Lawrence Loop Survey Feedback

Closing the remaining gaps in the Lawrence Loop has been identified as a priority throughout the Lawrence Bikes Plan update process. A public survey collected feedback on various alignment options to close these gaps. Below are the results of the survey and comments regarding each section.

Downtown Connection

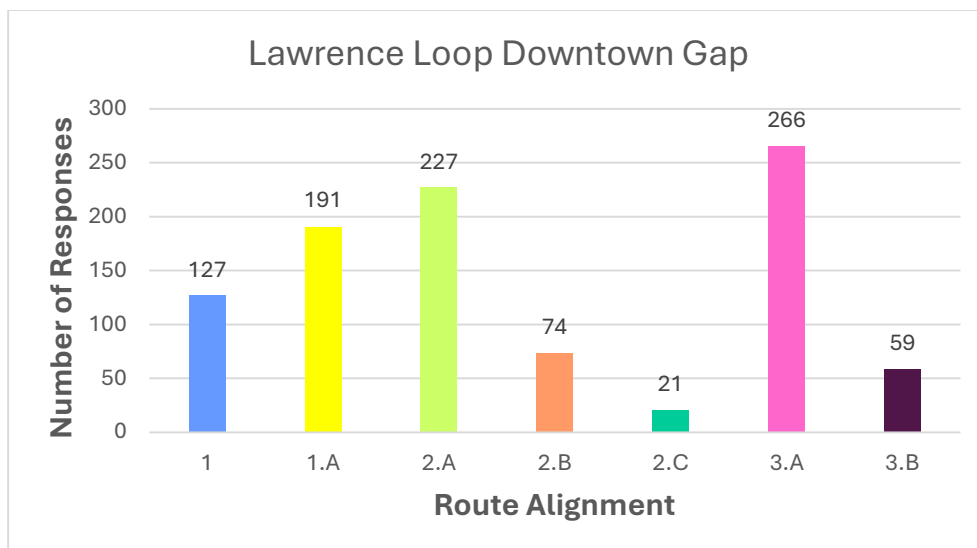
1.a,2.a,3.a	Option 3b would take the route through downtown traffic and the busy intersection at Sixth and Kentucky. Once you have 3a, the other parts will fall into place.

1.a,2.a,3.a	Separated path is preferred.
1.a,2.a,3.a	3b with a segment along Kentucky Street to the intersection with 6th Street -- and the routes that would feed that option -- seems very unsafe, both in terms of Kentucky Street traffic before 6th Street and at the 6th Street intersection. Vehicle traffic turns left or right at the intersection, and engineering some kind of safe "go through the intersection" option for bicycles or foot traffic seems very challenging.

1.a,2.a,3.a	Avoiding traffic lights and intersections should be a priority
1.a,2.a,3.a	It is critical that the loop trail avoids the very busy 6th and bridges intersection. We need to design this trail with children and old people in mind, it needs to be safe. The 1A route looks like it does this, it's hard to tell, does the 1A route go below the bridges? If so, then 1A is the priority route segment. Or will a dangerous crosswalk be there? The grade of the trail should be minimized, but that is difficult to discern on the map. The 3B route forces a big climb eastward up 7th street. Route 2c will be the most dangerous, crossing so much traffic.

1.a,3.a	3a is probably the real issue here. 3b takes you through multiple high traffic and highway intersections. Getting across those streets is the big problem. If you can solve that the other issues aren't as big. The second issue is at the junction where options 1 and 1a intersect. Westbound isn't an issue, but Eastbound on option 1, you approach a left turn across 7th street, with obstructed views around the corner on 7th street. During peak hours, there can be a lot of traffic at that spot. A separated lane on the North side of 7th street to avoid having to cross 7th when traveling eastbound could work similarly to a fully separated path like shown in 1a.

1,a,2,a,3,a	Section 3.a - I worked on the Ark City levee trail and we concluded that the only safe option for a busy highway crossing was under the bridge.
1,a,2,a,3,a	Under bridge makes the most sense to avoid crossing traffic
1,a,2,a,3,a	This combination (1a, 2a, 3a) would be the safest option for the majority of vulnerable road users. the other alignments would be important bikeways, but aren't suitable for the character and main purpose of the Loop- providing a safe and recreational path away from cars.
1,2,a,2,b,3,a	3a- I like this because it avoids the congestion at 6th in this area. 2c- Taking this route allows the bikers to detour into downtown if that is their destination, Also, I think New Hampshire is capable of supporting a bike lane. 2b & 1 - Once again, 7th street from NH to the Amtrak station is quite wide and will support a bike lane.
1,a,2,a,3,a	I ride the loop with my kids and I don't want to interact with traffic

1.2.b,3.b	I have concerns about the safety of path 1a along the rail road tracks. There would also be a significant incline up the backside of the hill from the rail road to the North end of Connecticut St.

Northeast River Connection

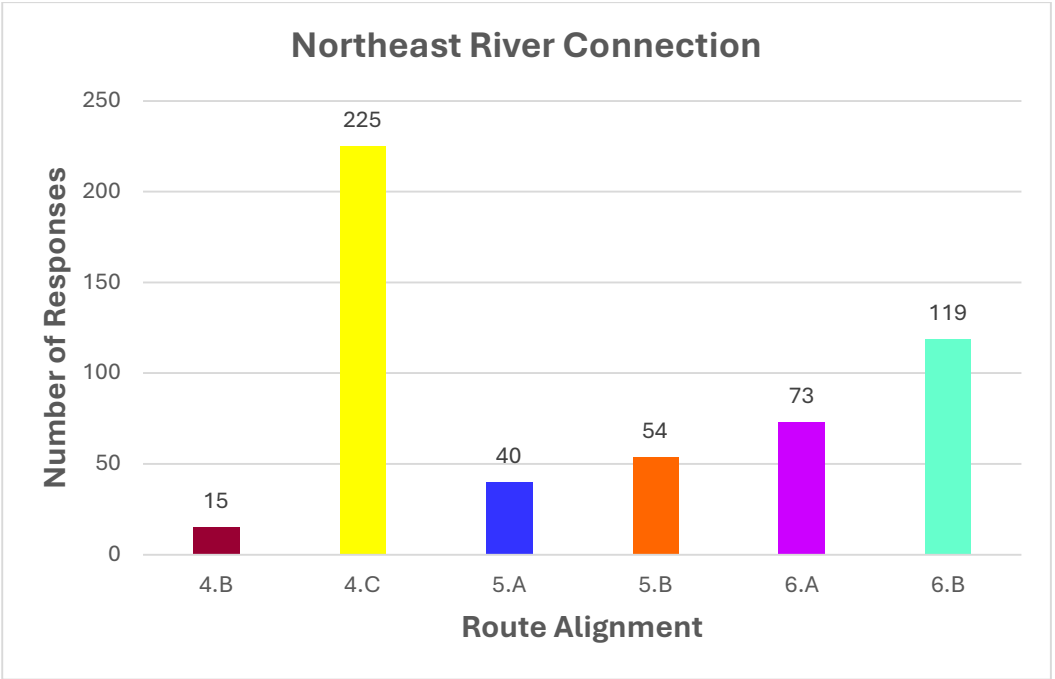
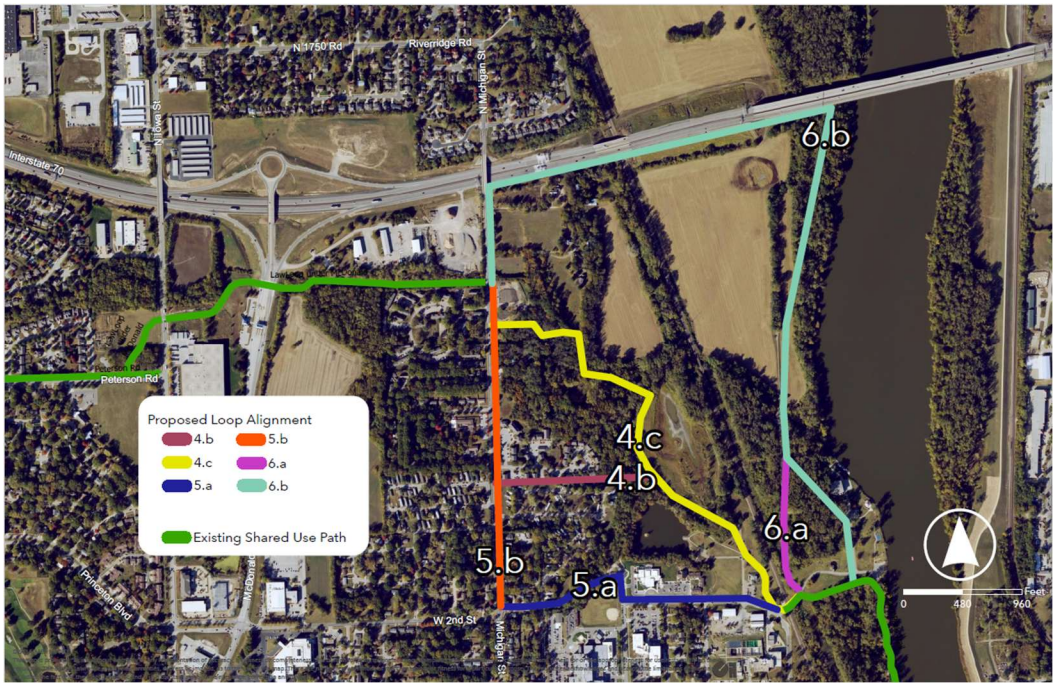
4.c	6a and 6b go right through what historically has been a homeless encampment which has now been cleared. I fear it would always be in danger of returning with more paths. I also worry about the ability to patrol, police, and provide emergency services along 6b -- and providing a new vector for homeless encampments there. In a perfect world it could be a stunning amenity, but in the world we live in an expensive one requiring too much commitment to safety.

4.c	I do not think 5 is a good option here. I think we need some more separation from the road after the nearby long mile parallel to Peterson Road to make this an enjoyable trail. I think the original plan of 4.c is still good (provided the homeless are removed from that area). If that is infeasible, I say 6 would be worth the cost, as it would tie in well with the future Cameron's Bluff park.

6.a,6.b	6a/6b keeps users out of traffic, which should be a main priority for a recreational path. These segments would also provide great access to the future Cameron's Bluff trail area. Please avoid on-street infrastructure for the Loop!

4.c,6.b	4c will be easiest from a bike navigation perspective. 6b would be an appropriate backup plan and include riverfront.
4.b,5.a	How are the woodlands that would be affected by 4.c managed? If building the bike lane would encourage their use or proper management, I am totally in favor of 4.c. Otherwise a small stretch of street adjacent path before cutting across (4.b) to the 4.c path makes sense to me.

5.a,5.b	While 6a and 6b might be a dream, the very high cost and easement issues scare me. Isn't part of this route contested by a very determined farmer? Let's not plan on an alignment we aren't 100% confident we can build in the next 4-5 years.

Northwest Corner Connection

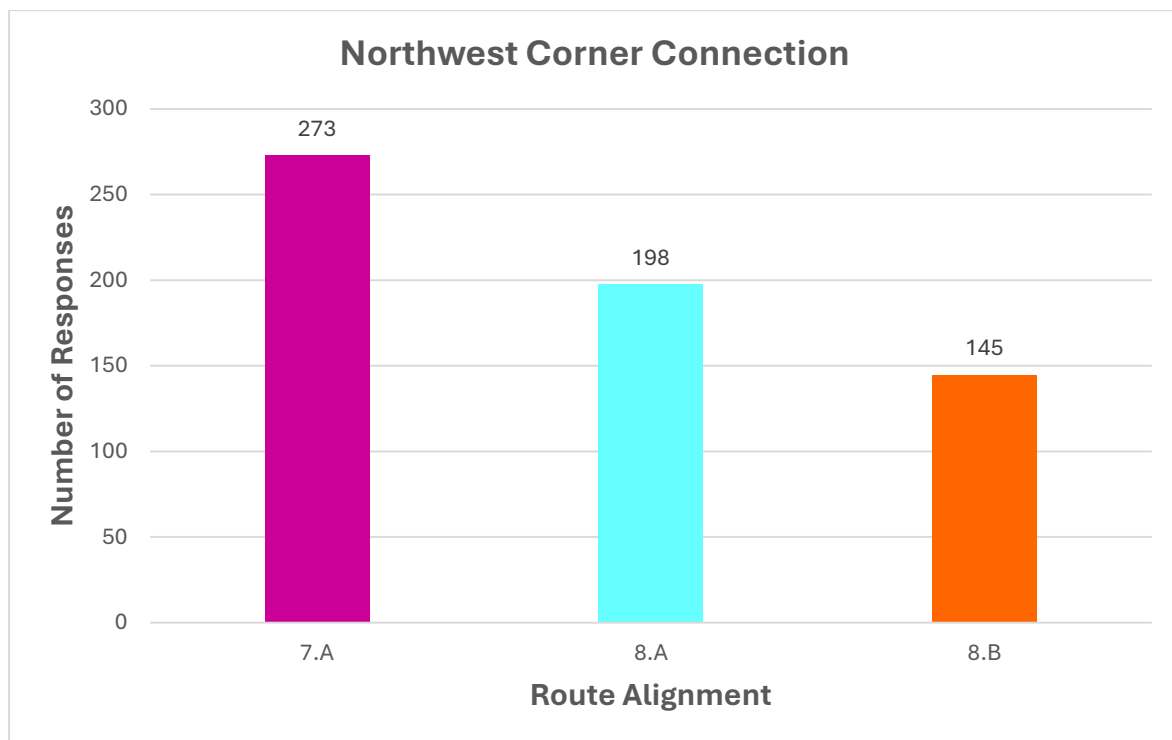
7.a,8.a	8b is a BIG hill, and I say that as a very experienced cyclist. 7a/8a provide a much more accessible option for the majority of users.
7.a,8.a	It's a toss up for me on this one. I could go for 7a-8b if the steep grade could be overcome by design.

7.a,8.a	The hill for 8b makes it not a great option with car traffic. Safety issues with going up that hill or down it with traffic.
7.a,8.a	8b is a Big hill! 7a/8a provide a much more accessible option for the majority of users.

7.a,8.a	Both 8a and 8b are good options, but 8b includes a serious elevation change that is not friendly to bikers.
7.a,8.a	Although I don't particularly like riding next to highways, I do not want to ride up and down E 1130 Road (option 8b), so my preferred route would be 8a to 7a. Riding along North 1750 Road (option 7a) seems a tad rough too, but hopefully, the bike path would make it pleasant.

Alignments Selected	Comments
7.a,8.b	8b is the clear winner over 8a. Nobody wants to run/bike next to the highway!!!
8.b	8b is the better path, but would need a dedicate path or lane. Currently biking on 1750 is taking your life into your hands. Fast traffic does not look for bikes nor does it slow when they come up on them.
7.a,8.a	8b would be hazardous for sharing the road with vehicle traffic and involves a material terrain change.
7.a,8.b	I like 7.a and 8.b. The current alignment is fine, the trail just needs to be separated from the road.

8.b	Stay away from highway.
7.a,8.a	Stick with the long standing game plan of 8a. Double-check to make sure the landowners of 7a agree with the path. Listening to the January 7 Steering Committee meeting 8b is something that was added as an option at the last second without proper investigation. It was such a last second addition that the people who live around 8b didn't start receiving postcards about the open house and survey until January 30. Some didn't receive them until February 2nd. E 1130 Rd is intimidating and is only used by die-hard cyclists. Very few people out for a leisurely recreational ride use this road. Cars use E 1100, N 1700, and E 1130 Rd as a racetrack like they used to do when Wakarusa was considered a drag strip outside of town. There is no way 8b is only grading. You're going to have to cut down a ton of trees that line both sides of the road just feet away. You're going to have to carve out hillsides or run well into the yards and across the driveways of county homeowners.

8.a	8a uses land already owned by the city with a portion already designated as a future park. The rest of the land is owned by Williams Management LLC who is building the future Hunter's Hill development and will likely annex and build on these parcels too. The future park would provide a drop-in point with parking for The Loop and the Martin Park Nature Park that's 200 yards away. It would also provide all current and future homes facing the highway with direct access to all these amenities. This wouldn't require going through anyone's property. 8b additional construction has to be more than just grading and has to include cutting down trees. E 1130 Rd changes elevation by 167 feet, serpentine back and forth, has no shoulders, and trees are one foot off the roadway with steep inclines/declines on both sides. Wakarusa Township has to do chip-n-seal over asphalt because of how slick the road gets. It would also require going through the yards of between 5 to 7 small rural properties.
